This Service Information bulletin supersedes SI B11 01 07 **dated February 2009**.

**N62 and N62TU Crankcase Ventilation System – Cold Climate Conditions**

#### **PROCEDURE A:**

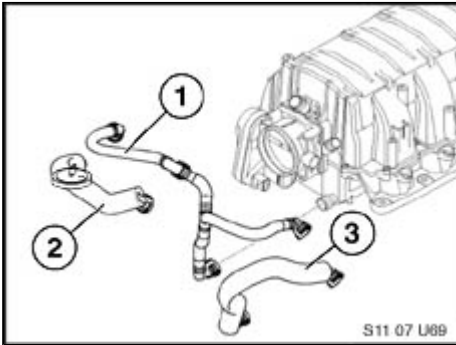
1. Replace the cylinder 1-4 head cover with P/N 11 12 7 563 474 with the updated crankcase ventilation valve.

2. Remove the crankcase ventilation plastic corrugated hose (1) connecting the two cylinder head covers and intake system. Install the modified insulated hose with the external pressure regulating valve (2), using P/N 11 61 7 563 476. Install the insulated hose (3), using P/N 11 61 7 547 186.

### PROCEDURE B

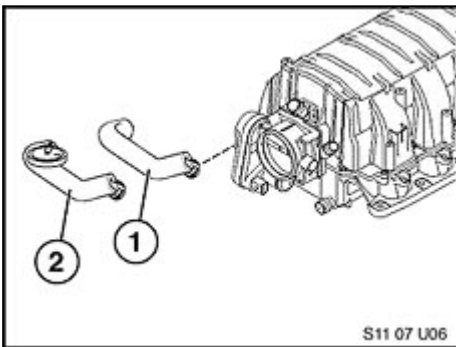
2. 1. Replace the cylinder 1-4 head cover with P/N 11 12 7 563 474 with the updated crankcase ventilation valve.

2. 2. Remove and discard the ventilation hose (1). Install the modified insulated hose with the external pressure regulating valve (2), using P/N 11 61 7 563 476 in the same location.

### PROCEDURE C

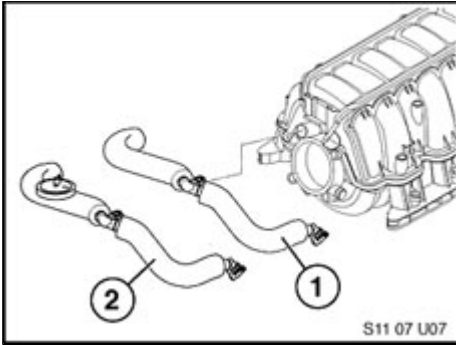
1. Replace the cylinder 1-4 head cover with P/N 11 12 7 563 474 with the updated crankcase ventilation valve.

- Remove the ventilation hose (1). Install the modified insulated hose with the external pressure regulating valve (2), using P/N 11 61 7 563 477 in the same location.
